**Building or Use Permit Pre-Application
Additions/Alterations/Accessory Structures
To Detached Single Family Dwelling**

BUILDING PERMIT REPORT

DATE: 5 APRIL 2000 ADDRESS: 84 Abby Lane CBL: 388A-B-006
REASON FOR PERMIT: To Construct 10'x12' addition to garage.
BUILDING OWNER: Therese H. LaRose
PERMIT APPLICANT: _____ CONTRACTOR Jim LaRose
USE GROUP: U CONSTRUCTION TYPE: 5B CONSTRUCTION COST: \$100,000 PERMIT FEES: \$20.00

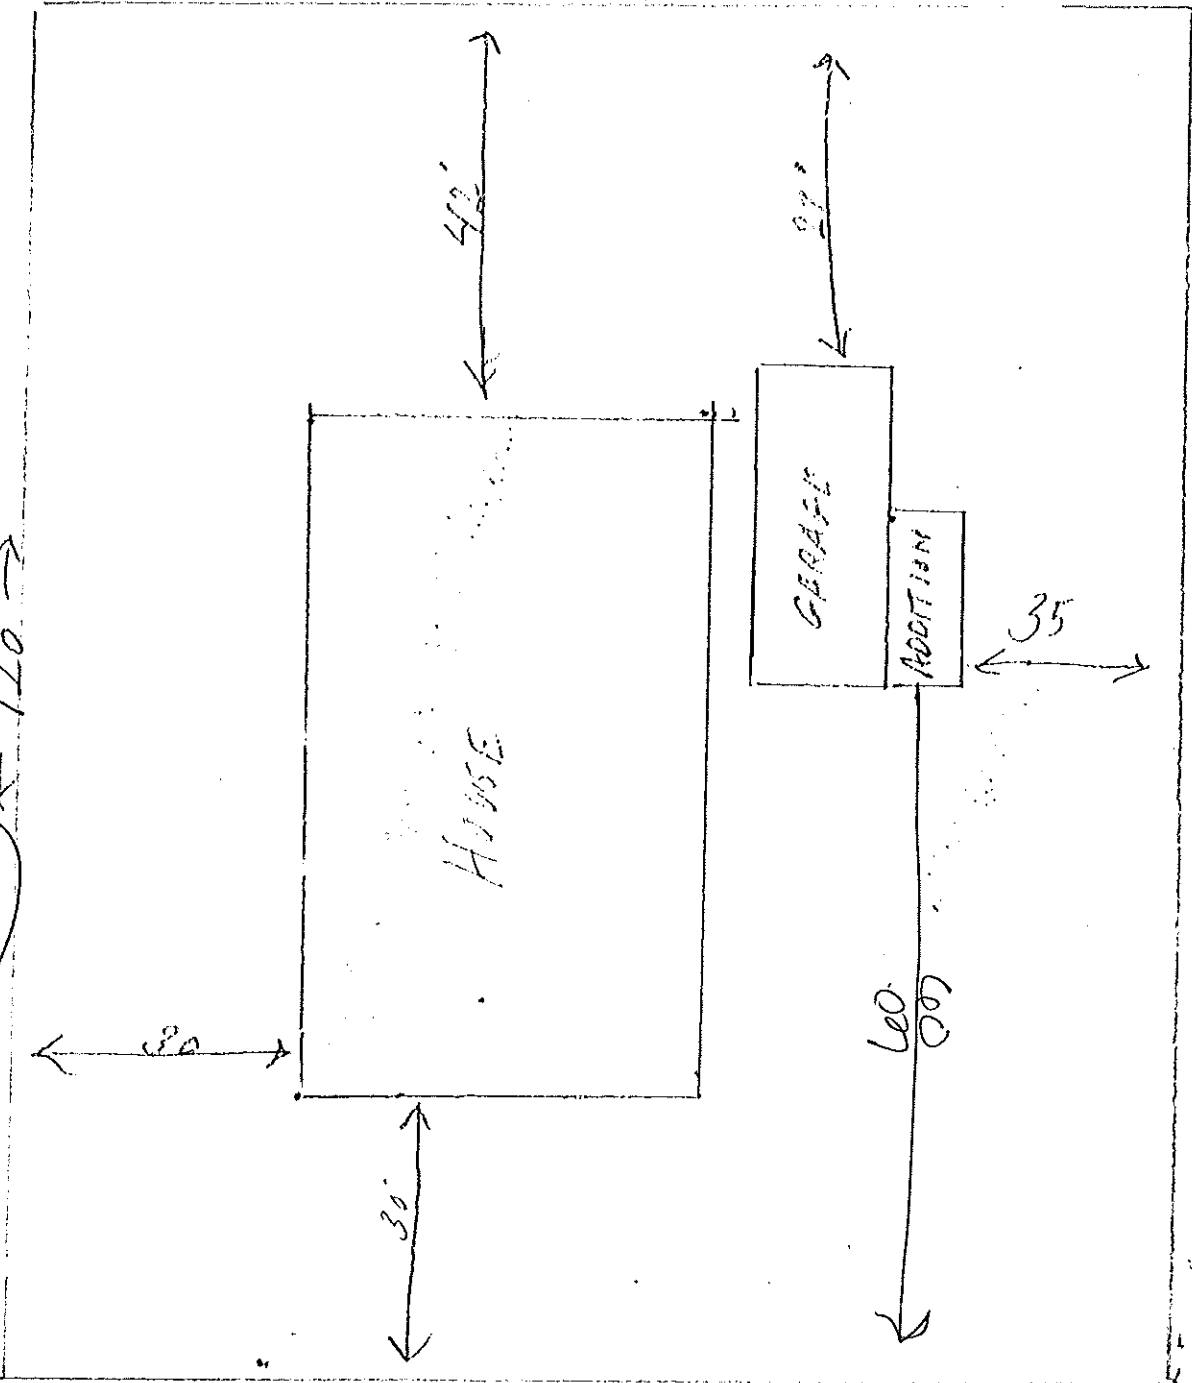
front - N/A
 rear 25' req - 35' shown
 side on side - 20' req - 27' shown
 side (60m) - 12' req - 60' shown
